**CITY OF HANOVER
PLANNING COMMISSION MEETING
MAY 22, 2019
AGENDA**

Re: *River Town Villas of Hanover Preliminary Plat Revised Submittal Review*
WSB Project No. 013676-000

As requested, we have reviewed the revised River Town Villas of Hanover preliminary plat documents as prepared by Loucks Inc., dated April 25, 2019 and we offer the following comments:

LANDSCAPE PLAN
L1-1

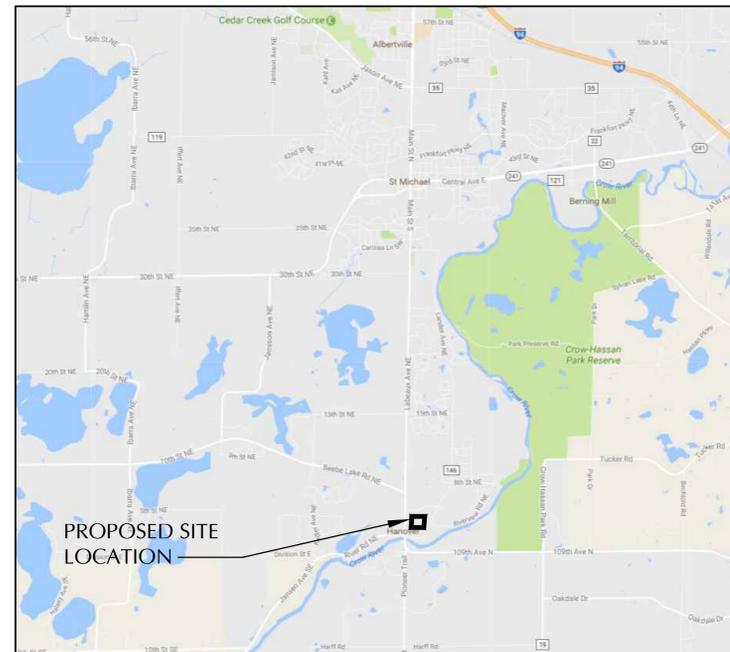
Sheet L1-1 contains the proposed landscaping plan. The landscaping plans generally identify more than 2 trees per lot to be planted, but given lot size the trees are proposed to be installed in the HOA owned area rather than on the individual lots. This variation can be approved as part of the PUD.
